CITY OF PORTLAND, OREGON

Staff Presentation to the
Portland Design Commission

LU 15-129978 DZM AD
Portland State University
School of Business Administration
(DAR – January 15, 2015)

May 21, 2015

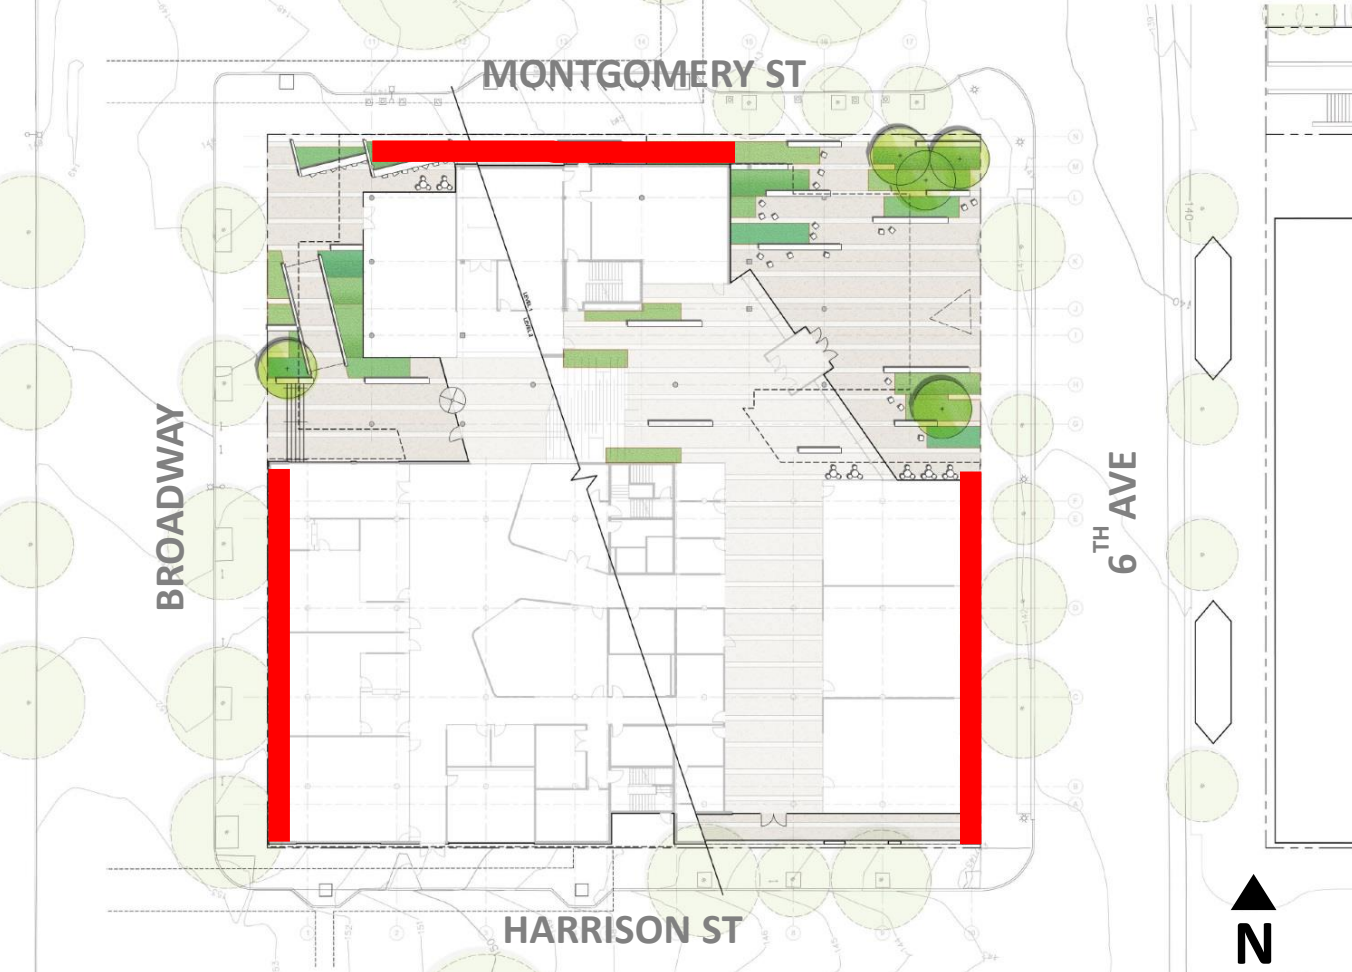
Main entrance must be within 25' of SW 6th Ave (Transit St)

Main entrance proposed to be approximately 33' from SW 6th Ave

STAFF SUPPORTS – Give back = plaza (Better meets: A8, B1, B4, B5).

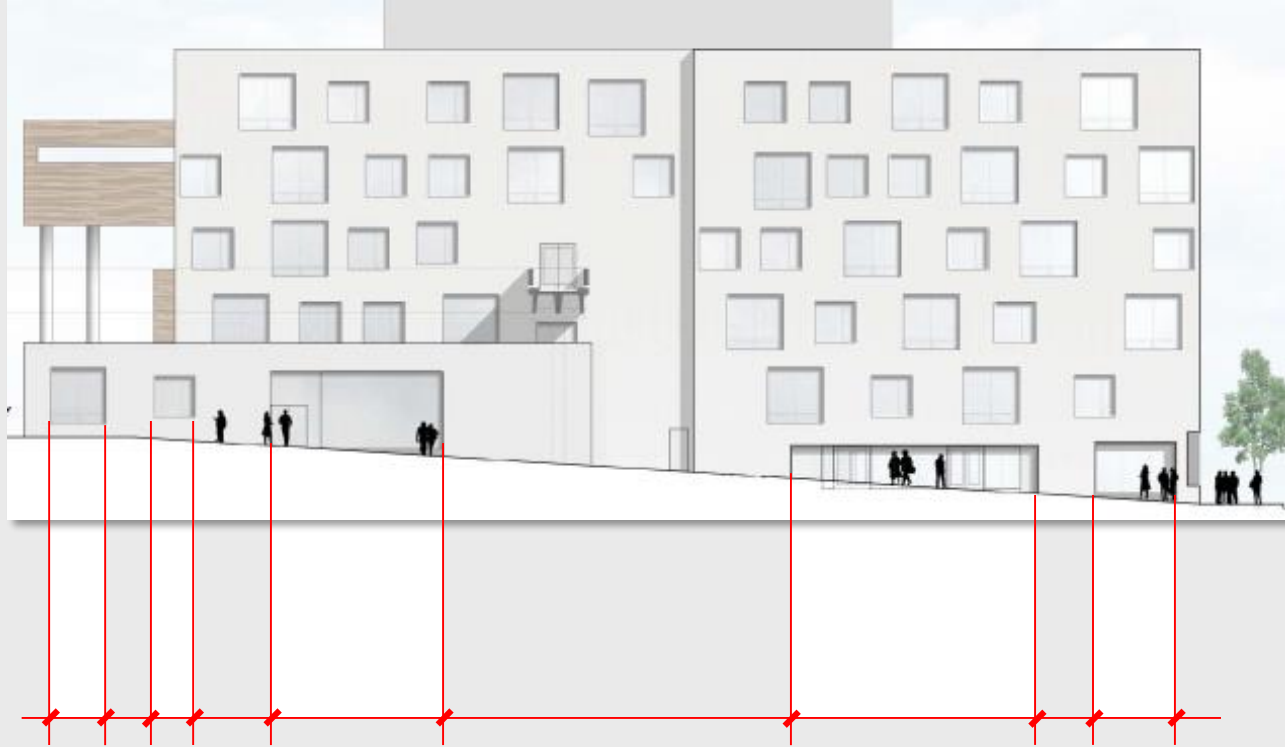
Buildings must be within 12' of property line for 75% of frontage.

SW 6th Ave & Broadway frontages: 52%
SW Montgomery St: 35%

STAFF SUPPORTS – Give back = plaza (Better meets: A8, B1, B4, B5).

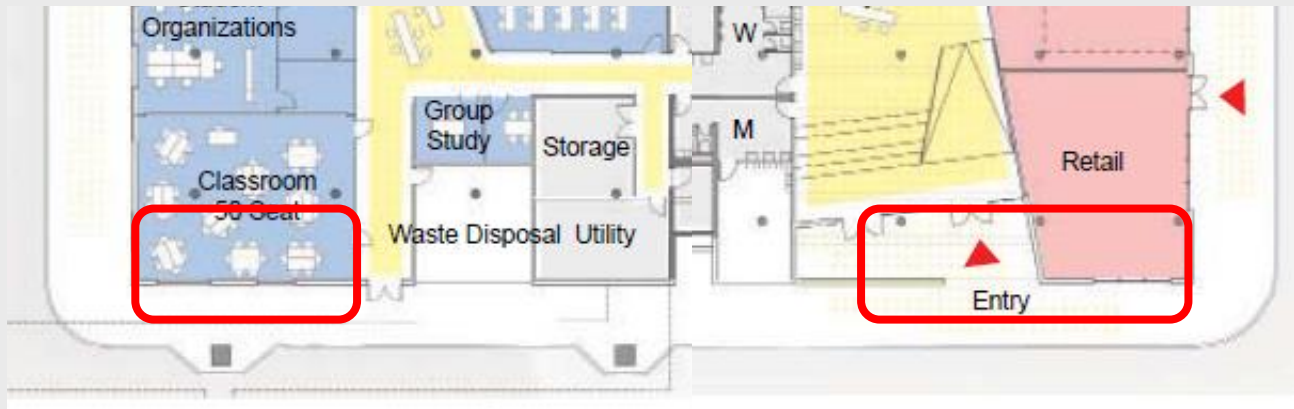
Windows must extend 50% of length and 25% of area on ground floor walls.

SW Harrison St: 44% length; 28% (meets)

STAFF DOES NOT SUPPORT – Applicant responding per Staff Report.

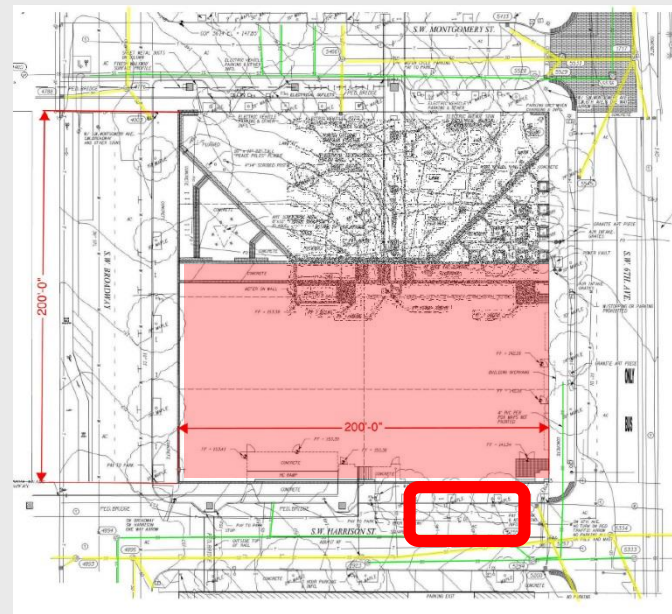
Ground floor active use must be 50% of length on all street frontages.

SW Harrison: 34%.

STAFF DOES NOT SUPPORT – Applicant responding per Staff Report.

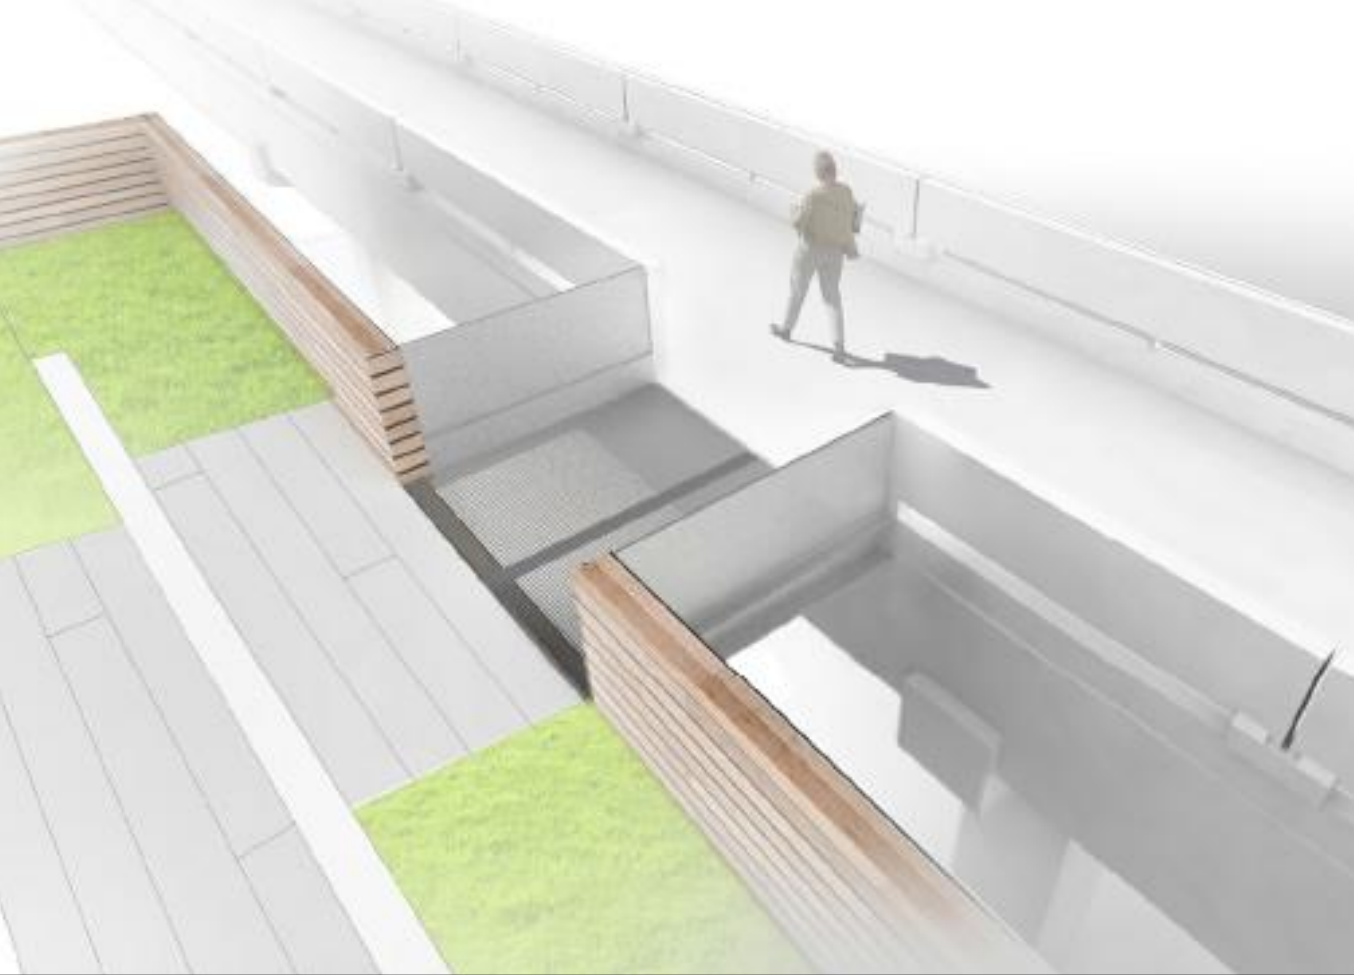
One (1) Standard A Loading Space

None

STAFF SUPPORTS – Integrated loading strategy with PSU Campus.

Skybridges

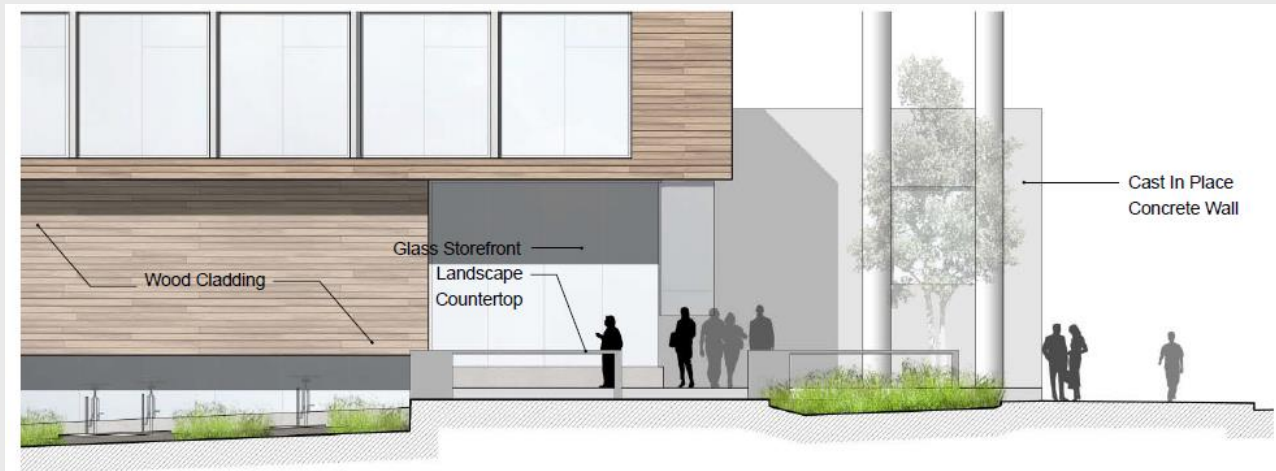
Major Encroachment Permit Application submitted, complete, Public Notice – 5.20.2015.

Among the CCFGs to consider are: A8, B1.

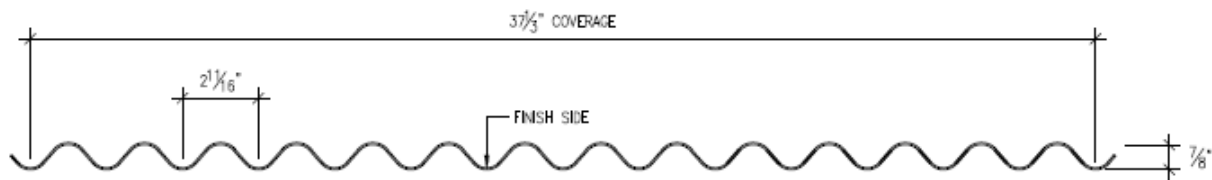
Integrated weather protection for pedestrians at all frontages of renovation.

Among the CCFGs to consider are: B6.

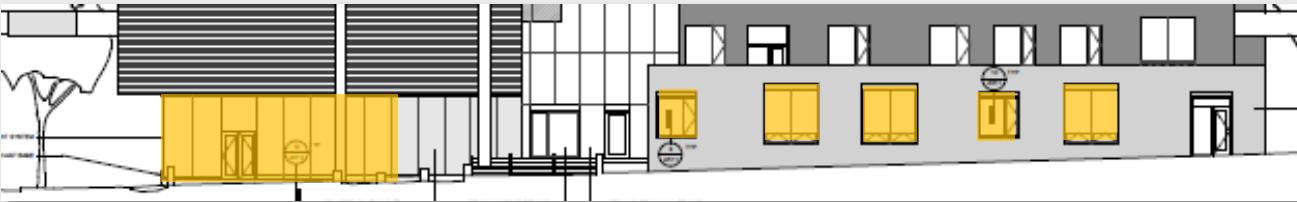
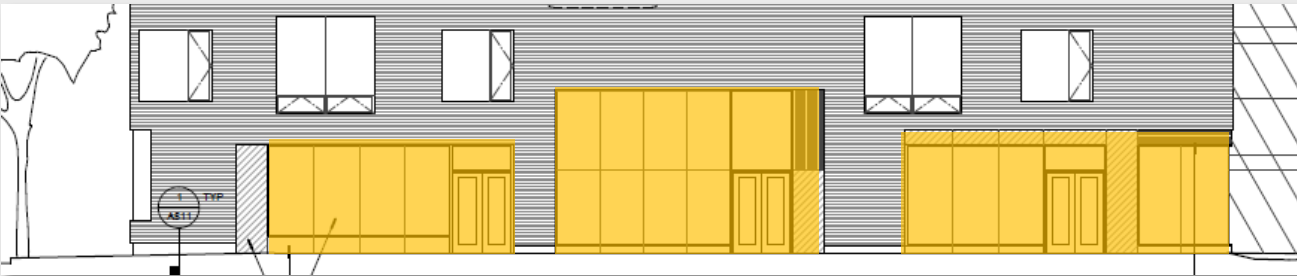
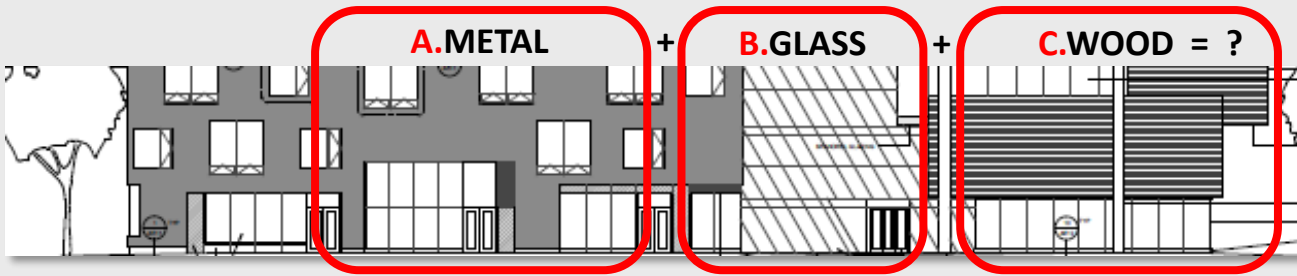
Specify wood species/fastening method & maintenance expectations. Eliminate metal from touch zone/better resolve fastening method (exposed).

Among the CCFGs to consider are: C2.
